The Applicant is also proposing flexibility with the following standards:

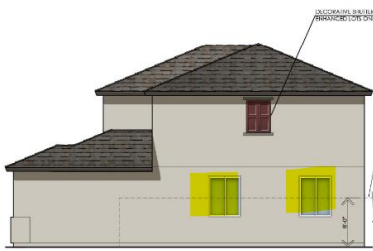
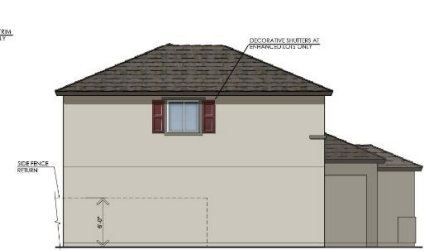
Analysis: Per the municipal code section above, trim at least two inches in depth shall be provided around all windows, or windows shall be recessed at least two inches from the plane of the surrounding exterior wall. The project does not provide trim around all windows, see below highlighted elevations. For this reason, the applicant requests flexible development standards per the code.

First Floor Plan

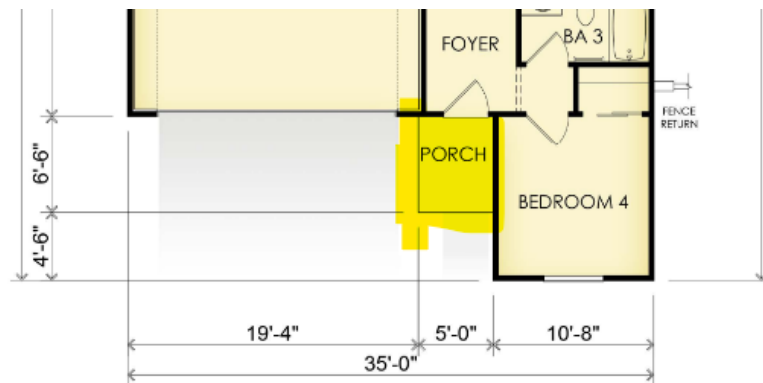
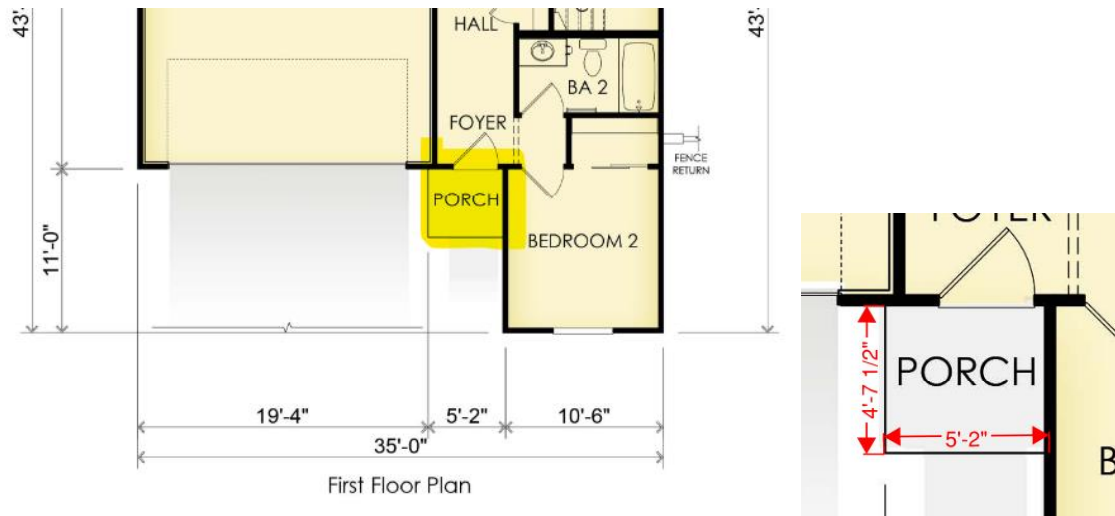
Analysis: Per the municipal code section above, building entries shall be 36 SF. The below highlighted building entries range from 22SF – 32.5 SF - 35 SF. For this reason, the applicant requests flexible development standards per the code.

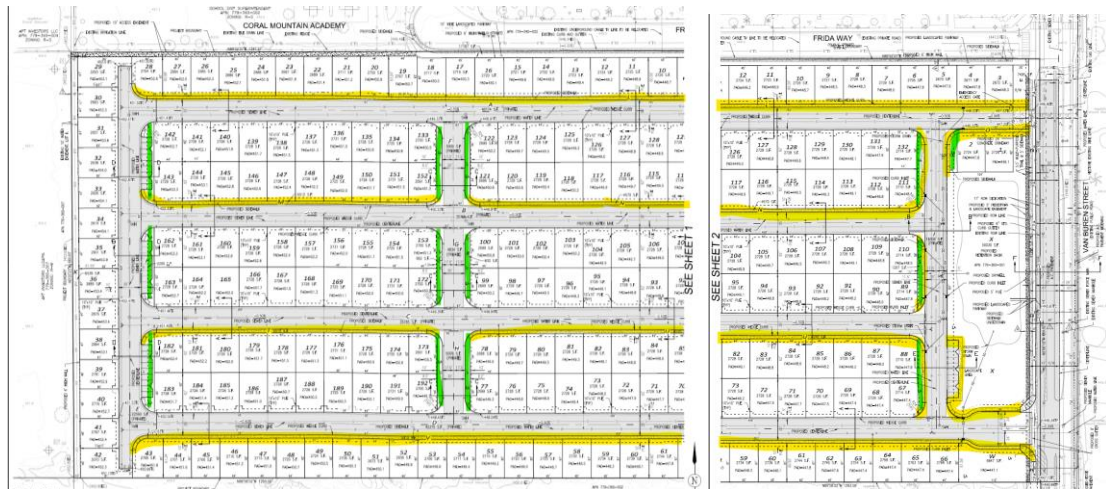
Per the municipal code section above, the applicant is required to provide the following elements: Equestrian and agricultural themed improvements including equestrian rail fencing, agrarian lighting, agrarian signage, 10-foot-wide decomposed granite multi-purpose trail and date palms planted twenty (20) feet on center shall be incorporated with new development along Avenue 50, Avenue 52, Van Buren Street and Calhoun Street South of Avenue 50. The project does provide an equestrian fence design, however does not meet the specific requirements above. The equestrian design provided in the plans provides a 5' 6" decomposed granite trail instead of a 10-foot granite trail. The project also does not provide date palms. For this reason, the applicant requests flexible development standards per the code.
